**ZONING AMENDMENT,  
PLANNED UNIT DEVELOPMENT &  
SUBDIVISION STAFF REPORT**

**Date: July 7, 2011**

<b><u>NAME</u></b>	Dog River Venture, LLC
<b><u>SUBDIVISION NAME</u></b>	Grandview Apartments Subdivision
<b><u>LOCATION</u></b>	6151 Marina Drive South (East side of Marina Drive South at the mouth of Dog River).
<b><u>CITY COUNCIL DISTRICT</u></b>	District 3
<b><u>PRESENT ZONING</u></b>	R-1, Single-Family Residential District
<b><u>PROPOSED ZONING</u></b>	R-3, Multiple-Family Residential District
<b><u>REASON FOR REZONING</u></b>	Changing conditions.
<b><u>AREA OF PROPERTY</u></b>	16.1 Acres ±
<b><u>CONTEMPLATED USE</u></b>	<p>Subdivision approval to create 2 legal lots of record from an existing metes and bounds parcel, Planned Unit Development Approval to allow multiple buildings on a single building site with shared access and parking between two building sites, and Rezoning from R-1, Single-Family Residential District, to R-3, Multiple Family Residential District to allow an apartment complex.</p> <p><b>It should be noted, however, that any use permitted in the proposed district would be allowed at this location if the zoning is changed. Furthermore, the Planning Commission

# SITE PLAN

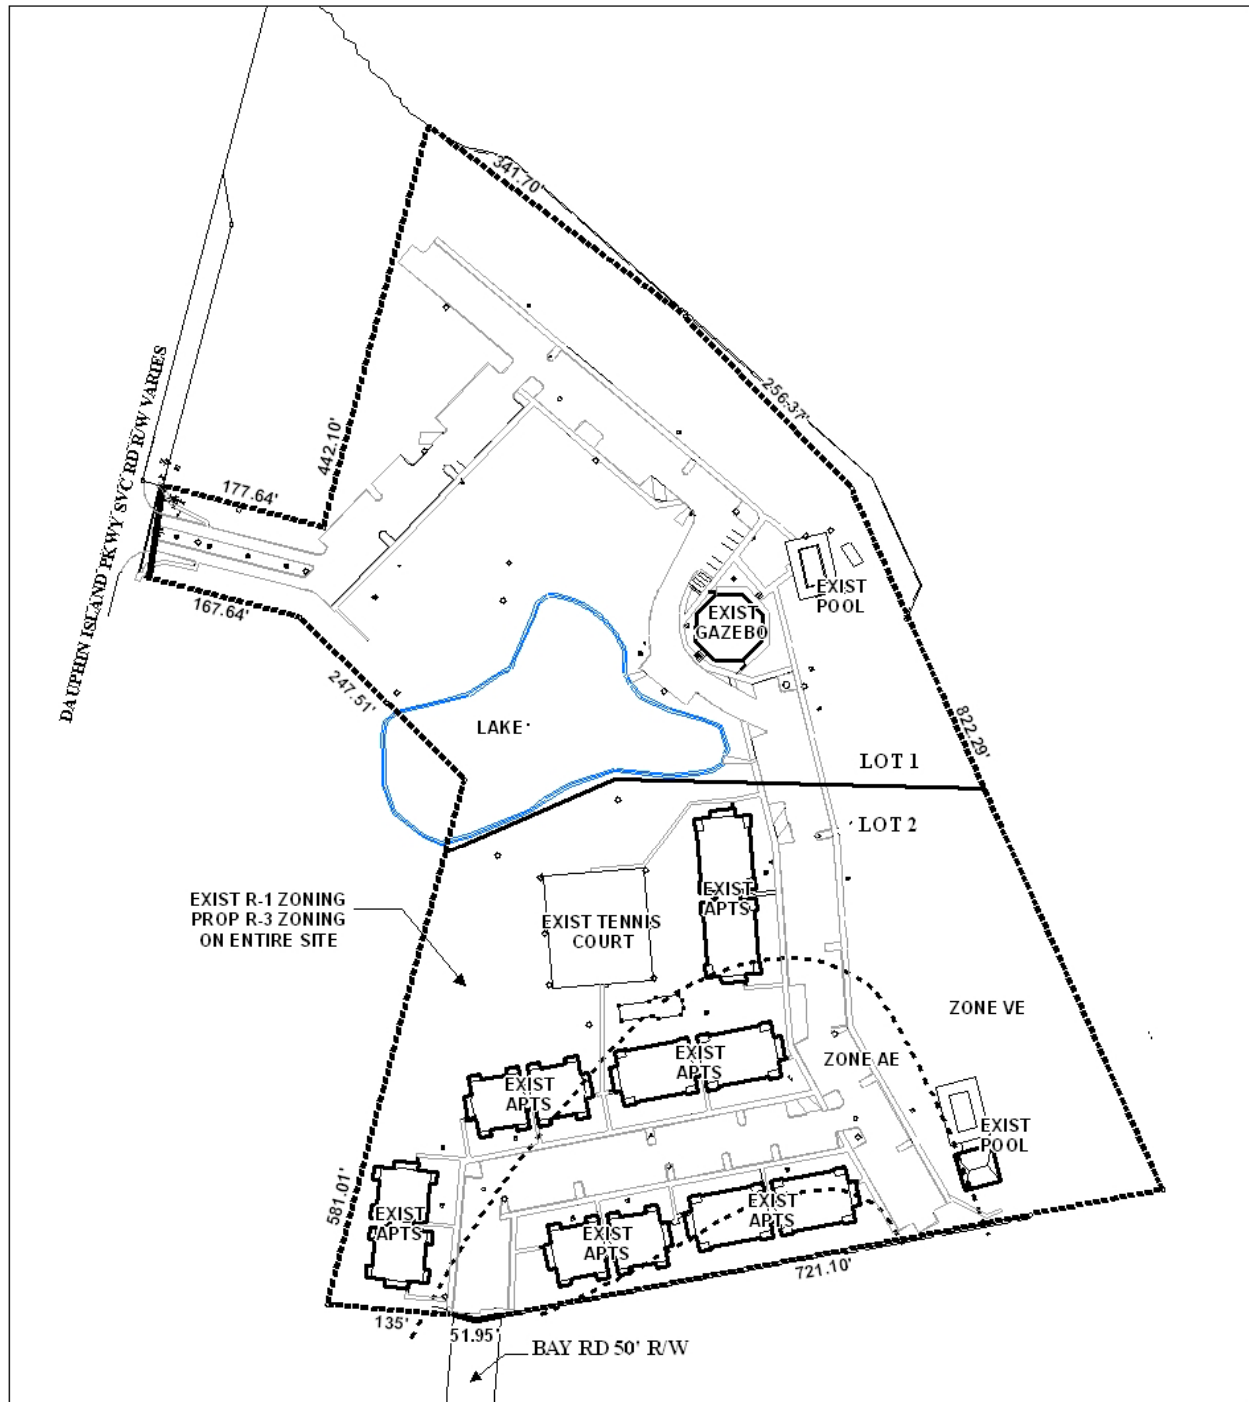
In this case, the site plan submitted by the applicant does not depict all of the improvements on the site, including fences, parking spaces, and dumpster locations. In addition, a gated entrance at Marina Drive South was constructed without permits at some point, and is also not shown on the site plan. The site plan should be revised to depict all improvements, existing and proposed.

- 1) depiction of all improvements on the site including fences, parking space, and dumpster locations;
- 2) depiction of the front entrance gate and queuing spaces along Marina Drive South;
- 3) depiction of parking spaces and sizes;
- 4) depiction of parking calculations;
- 5) depiction of dumpster enclosures;
